I apologize in advance if everyone thinks that the "hiss mod" has been talked to death. I'm finally ready to do the mod and have some thoughts that I'd like vetted out. My opinion is that there is one slight flaw that might compromise performance.

After acquiring some well spec'ed Murata 6KHz BW, 6 Pole, 455 KHz filters from Mouser, I started reviewing the "hiss mod" instructions. The mod basically entails inserting the filter between the output of a IF transformer (T2002) and one of the inputs to a dual-gate FET (Q2033).

Murata CFWLA455KHFA-B0:

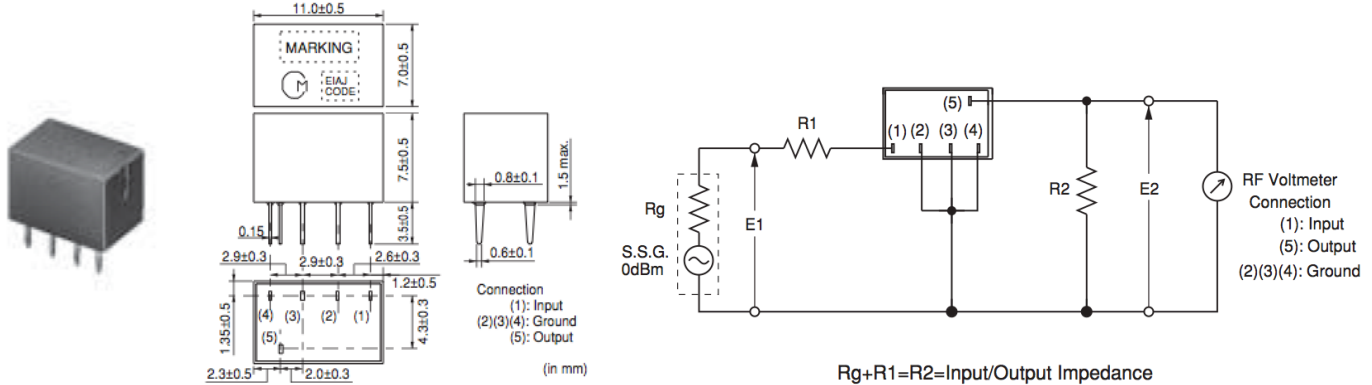
To facilitate the hiss mod, thermistor TH2002 is removed and the new 455 KHz filter is basically inserted in it's place. The Murata filter specs are that it should have a impedance driving it of 2k ohms and the output should be looking into a load of 2k ohms.

I am not suggesting that the modification doesn't work. I know that it does from what others who have done it reported back (thanks to those folks). My thought is just that the filter response is compromised when you start deviating from what the filter is supposed to see driving it. If it was acceptable to the filter makers then they would have given an impedance range but we know that this isn't the case.

Pertinent part of Yaesu FT-990 IF board schematic:

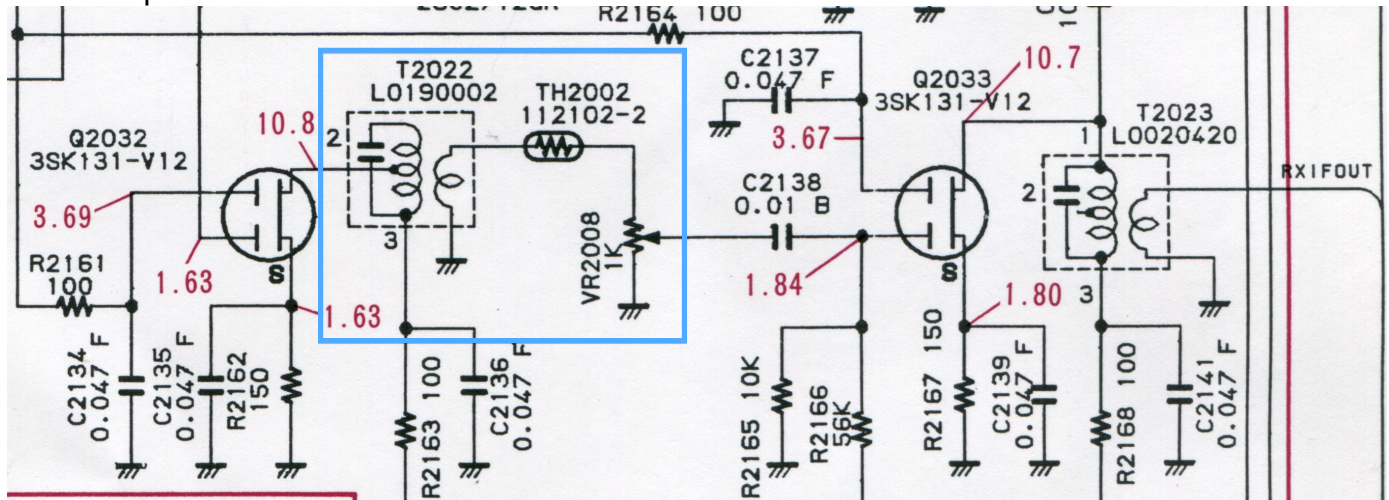
The FT-990 "hiss mod" basically removes thermistor TH2002 and inserts a 455 KHz, 6 KHz BW filter, such as the one above, in its place. The output of the filter is to have a 1k resistor in series, so that in combination with the existing pot, VR2008, it will be looking at a 2k ohm load. The input to the filter is said to need a 2k resistor to ground in order that it see a 2k impedance source... HOWEVER, I contend that this resistor would be in parallel with the output impedance of T2022. T2022 output link is likely a fairly low impedance as it was to drive the load of TH2002 (~500 ohms*) in series with VR2008 (1k ohm). * measured at room temp

If the output link of T2022 represents a impedance that is 2k or less then the input of the 455 KHz filter is going to see 1k ohm or less driving it. My worry is that this differs significantly from the required 2k impedance that the filter expects; enough to cause it to behave measurably less than ideal.

The mod has us putting a 2k ohm resistor from the input of the 455 KHz filter to ground. I believe that it is explained that this will provide the proper input impedance to this filter (2k ohms). However, it seems to me that one is really putting a 2k resistor in parallel with the output coupling link of the IF transformer that is providing the drive to it

(T2002). And since that transformer was previously driving approximately 1.5 kohms of load, it was probably designed to have an impedance comparable or lower than this. If so, in essence, then we are presenting an impedance of less than 1k ohm to the input of the new filter (2k ohm in parallel with <2k ohm).

Sanity check anyone? My thought is that we may need a bit of series resistance from the IF transformer output to the new 455 KHz filter input, perhaps as low as zero ohms but possibly as much or more than 1.5 kohm.
